Response to Referee #1:

We appreciate the very helpful feedback from the referee. The referee's comments are listed in *italics*, followed by our response in **blue**. New/modified text in the manuscript is in **bold**.

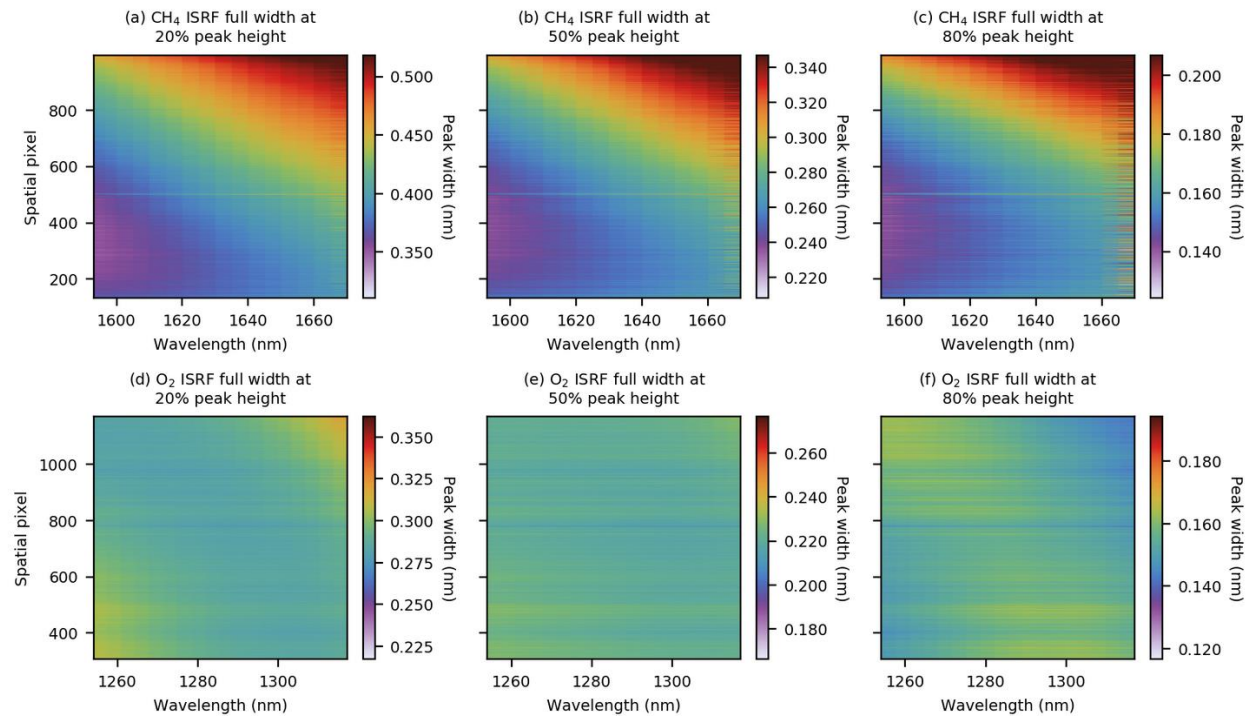
6. Figure 14: For the total ‘smoothed’ ISRF there are discrete transitions. It appears there is no truly smooth ISRF. Why was this done? Please explain.

The transitions correspond to the discrete wavelengths where ISRF measurements were collected. Figure 14 has been updated using Gouraud shading in order to show the smooth ISRF variation across the FPA. The updated Figure 14 and caption is included here:
